Access Compliance Report Public Rights-of-Way (Curb Ramps)

Main Street: ETON_PL Cross Street: FAIRHAVEN_AVE Location: SW

ADA ID: RPRK211007110847 Ramp Type: Type 1 - Perpendicular Diagonal Initial Pass/Fail: Fail Overall Compliance: No Severity Score: 16

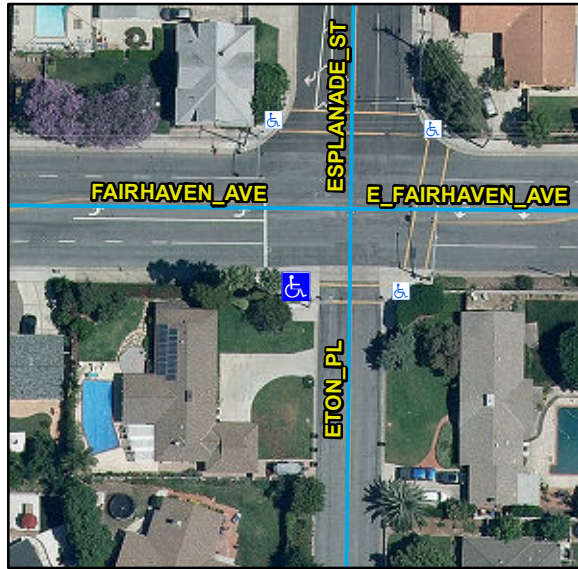
Remove & Replace Curb Ramp With Two New Directional Ramps or Equivalent. Restripe Crosswalk.

R304.2.2, R304.5.3, STD 1115
